FAIRFAX COUNTY PLANNING COMMISSION

PUBLIC HEARING FOR PLANNING DETERMINATION

Application Number:	**2232-M13-14**
Applicant:	**Fairfax County School Board**
Proposed Use:	Elementary School
Supervisor District	Mason District
Subject Property:	Tax Map 51-3 ((1)) 30, 31; 51-3 ((11)) 188A; 51-3 ((13)) 5, 10, 11 6245 Leesburg Pike, Falls Church, VA 22044
Area of Subject Property:	3.43 acres
Application Accepted:	October 16, 2013; revised November 12, 2013
Recommendation:	In accordance with Va. Code Sec. 15.2-2232, as amended, staff recommends that the Planning Commission find the proposal by the Fairfax County School Board, as amended, to retrofit the existing office building for elementary school use, at 6245 Leesburg Pike, Falls Church, VA 22044, substantially in accord with provisions of the adopted Comprehensive Plan.

Staff concludes that the subject proposal by the Fairfax County School Board, as amended, to retrofit the existing building for elementary school use, located at 6245 Leesburg Pike,
Falls Church, VA 22044, satisfies the criteria of location, character, and extent as specified in Va. Code Sec. 15.2-2232, as amended. Staff therefore recommends that the Planning Commiss

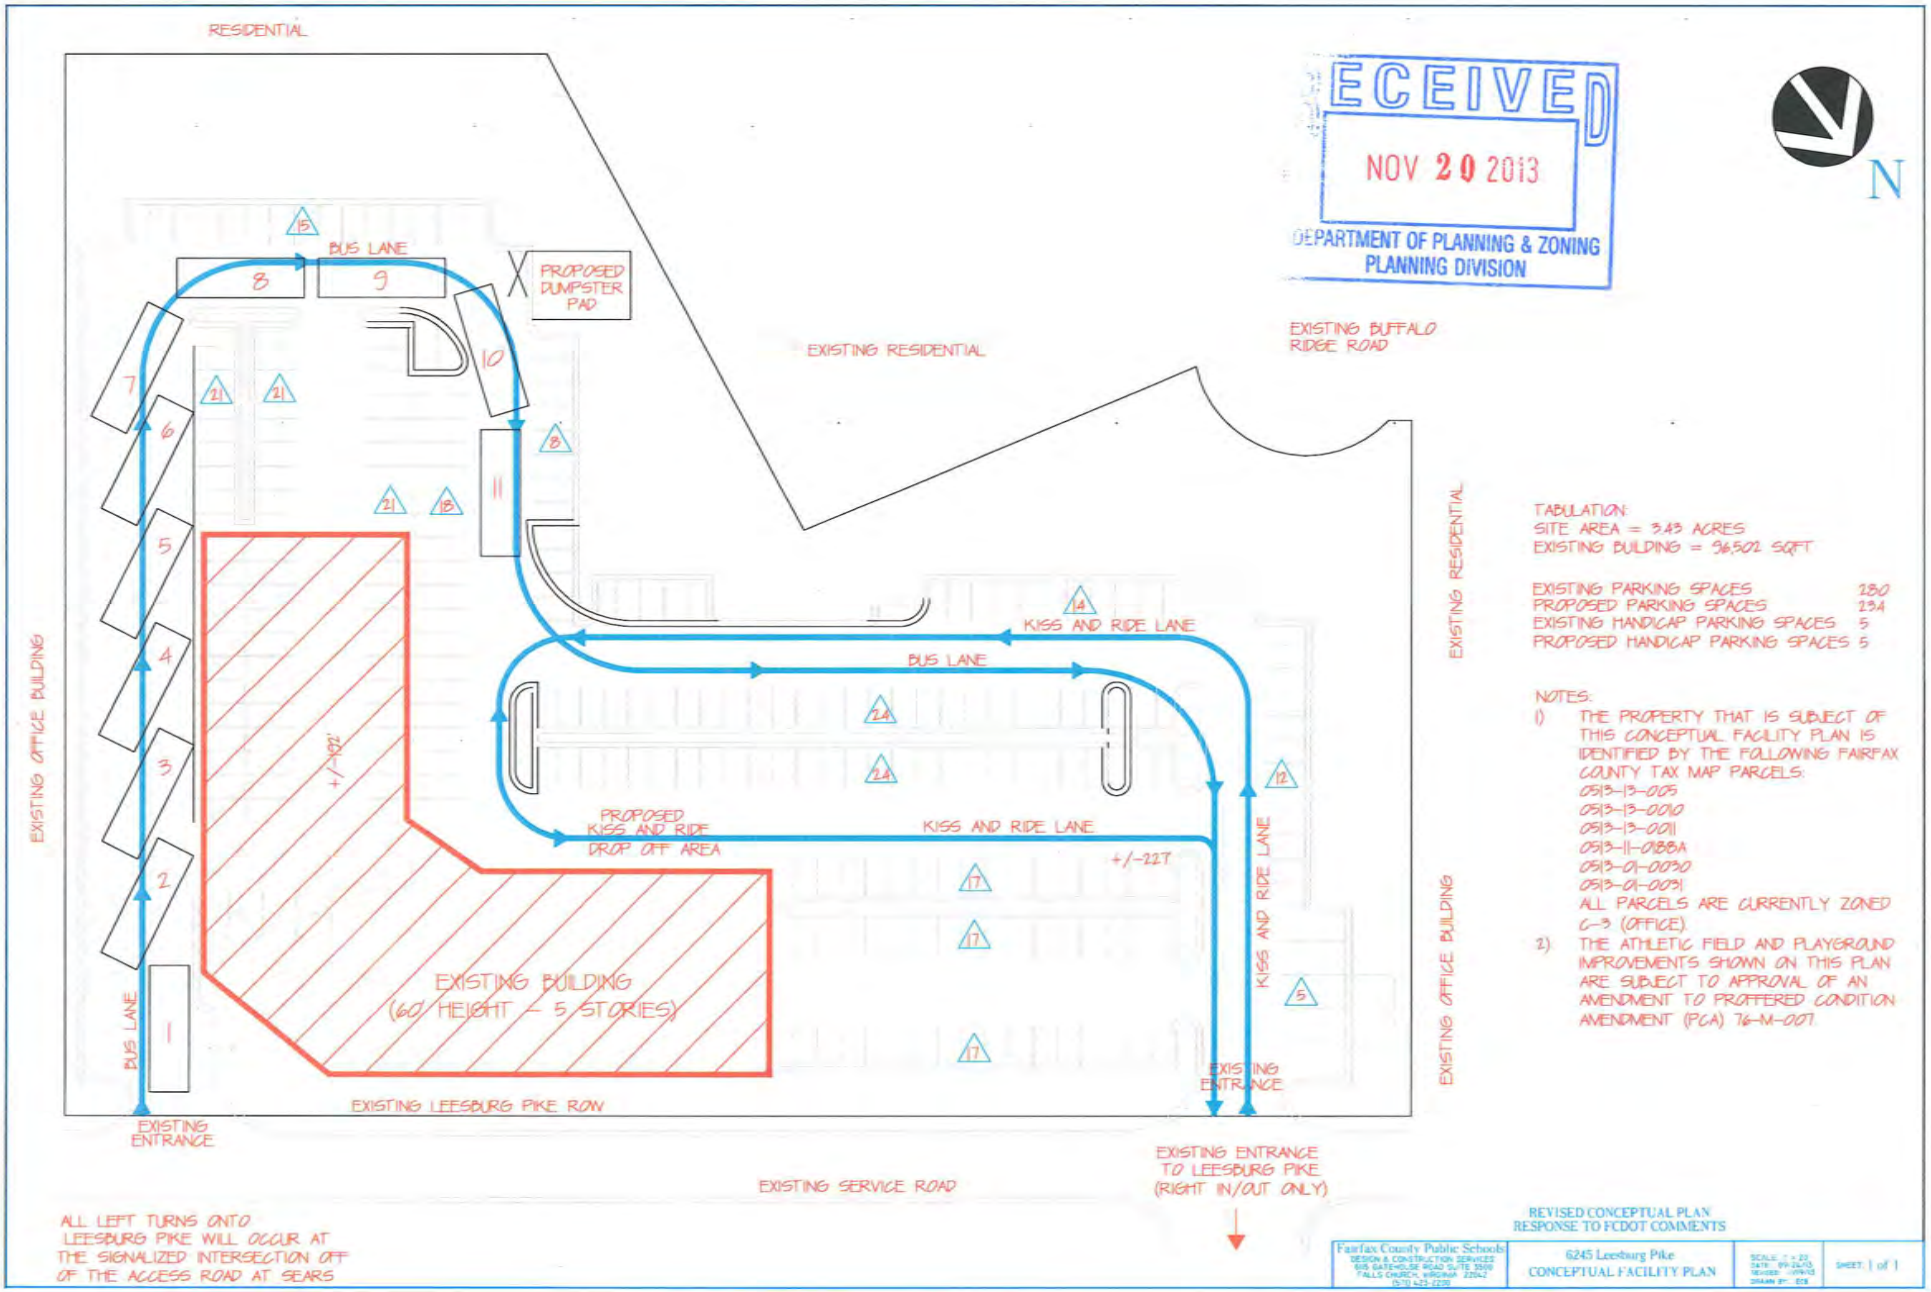
General Comment: Chapter 122 of the Fairfax County Code, (Tree Conservation Ordinance) and Section 12 of the Public Facilities Manual (PFM), requirements for tree conservation, have not been addressed in this application. Additional comments are provided addressing the 10-year tree canopy and landscaping requirements that will need to be met with any site improvement as part of any future plans such as the PCA that will be required for the proposed parking lot, athletic field, and playground.

1. **Comment:** It is unclear what type of vegetation is present onsite since an existing vegetation map (EVM) has not been provided.

2. **Comment:** Preliminary 10-year canopy calculations have not been provided and it is unclear how the tree canopy requirements (10%) will be met for the site.

3. **Comment:** It is unclear how the Tree Preservation Target will be met for the site since no calculations have been provided.

4. **Comment:** It appears that transitional screening and a barrier is required on the southern and western sides of the property based on the surrounding residential uses.

5. **Comment:** It is unclear how the site may be landscaped.

6. **Comment:** It is unclear how interior parking lot landscaping requirements will be met.

7. **Comment:** It is unclear how the peripheral parking lot landscaping will be met along the eastern and northern sides of the site.

8. **Comment:** The limits of clearing and grading are not shown on the plan, making it difficult to tell which existing vegetation will be preserved.

Water Quality Control
The conceptual facility plan does not have detailed information however, indicates that the plan will modify parking area and add athletic fields. Since the parking space in proposed conditions are being reduced, the site may qualify for redevelopment and water quality requirements for redevelopment shall be met during the site plan submission.

Stormwater Detention
Detention requirements must be met if not waived (PFM 6-0301.3). The conceptual plan does not have enough information to review the detention requirements. However, the peak post development runoff for 2-year and 10-year storm shall be less than that of pre-development runoff. In addition to this, the site plan shall detain 100-year storm event on the portion of the site located in Four Mile Run Watershed.

Onsite Major Storm Drainage System and Overland Relief
Applicant needs show that no buildings will be flooded with a 100-year design flow, even if the minor system should fail due to blocking. Applicant needs to provide an overland relief narrative and arrows showing runoff flow path of the 100-year storm event. Cross-sections at key locations including the building entrances must be shown on the site plan submission.

Recommendation: The applicant should provide an accurate EVM that depicts the location of any cover types identified in PFM Table 12.2 and one that meets the requirements of Zoning Ordinance, Chapter 112, Article 13 and all elements of PFM 12-0506.

Recommendation: The applicant should provide 10-year canopy calculations contained with table 12.10 from the PFM to demonstrate how 10-year canopy requirements will be met for the site in accordance with PFM 12-0511 and Article 13.

Recommendation: Information included in the EVM should be utilized to provide a Tree Preservation Target level in accordance with PFM 12-0508. The Tree Preservation Target Calculations and Statement should be provided as shown in table 12.3.

Recommendation: The uses and zoning of the surrounding parcels should be added to the plan and Transitional Screening Type I (25 feet wide) along with a Type D, E, or F barrier provided as required by 13-302 and 13-303 of the Zoning Ordinance. A matrix should be provided to show how this requirement will be met.

Recommendation: The landscape plan should be submitted that depicts using a key and symbol the different categories of trees and shrubs, their size, quantity, and 10-year canopy cover that will be provided. It should be noted on the plan that a variety of suitable native and desirable trees and shrubs will be provided throughout the site with the site plan. The applicant should consider using species that provide the opportunity to receive additional canopy credits in exchange for planting trees that provide specific environmental and ecological benefits, or species that are resistant to disease, pests, decay and negative impacts such as drought.

Recommendation: The applicant should provide tabulations and landscaping to depict how the property that abuts the right-of-way along the northern side of the site, along with property along the eastern side of the site will met peripheral parking lot landscaping requirements in accordance with ZO 13-202.

Recommendation: The limits of clearing and grading should be added to the landscape and tree preservation plans as may be necessary for any site work proposed.

Fairfax County Public Schools DESIGN & CONSTRUCTION SERVICES 8115 GATEHOUSE ROAD SUITE 3500 FALLS CHURCH, VIRGINIA 22042 (571) 423-2200	6245 Leesburg Pike CONCEPTUAL FACILITY PLAN	SCALE: 1" = 80' DATE: 09/24/13 REVISED: 11/08/13 DRAWN BY: ECB	SHEET: 1 of 1

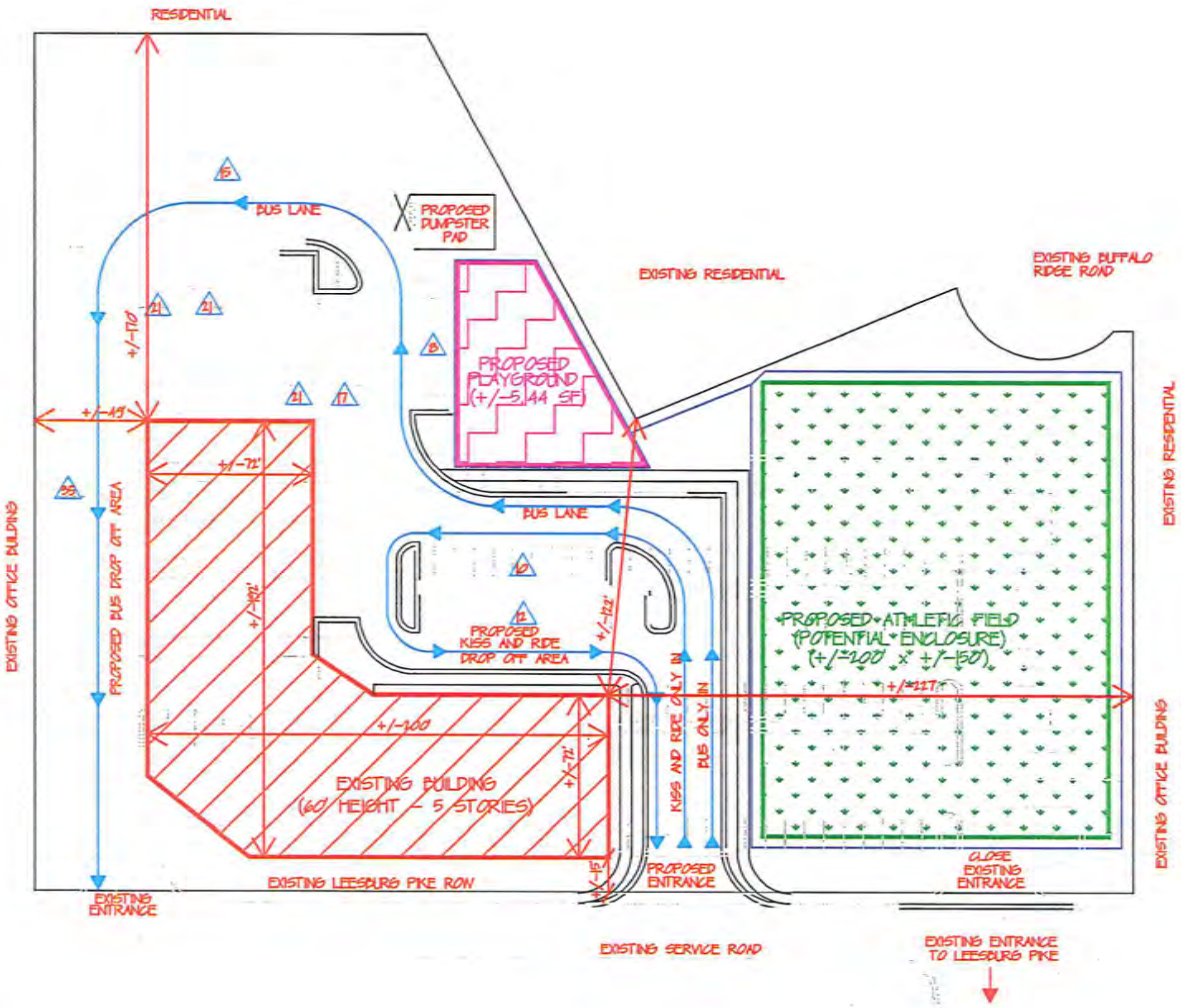
- A site circulation plan should be provided for when the school opens, if that occurs prior to the future circulation improvements shown on the conceptual plan. This circulation plan has been provided and is included in Attachment A – "Revised Conceptual Plan".

- There are substantial issues related to on-site vehicle circulation for buses and for cars that need to be addressed. These are detailed below:
  - The application provides a longer range site plan for the proposed school that includes planned improvements to the site to address circulation. However, the application also states that "the School Board proposes to initially modify only the interior of the existing building for use as a new elementary school". No indication of the timing of the opening of the school, or the timing of future improvements is provided. The applicant needs to provide a site circulation plan for when the school opens but prior to future circulation improvements as proposed in this application.

- Since access to the site is currently, and proposed to be, off the Route 7 access road, school buses will be required to make sharp turns from Route 7, onto the access road and then make additional sharp turns into the site. The applicant should provide documentation indicating buses are capable of making these sharp turns and what impact their turning movements will have on vehicle traffic along Leesburg Pike.

- The applicant should provide a plan indicating how school buses will access the site utilizing the nearest signalized intersection, currently the signal at Route.7 and the Seven Corners Shopping Center Entrance.
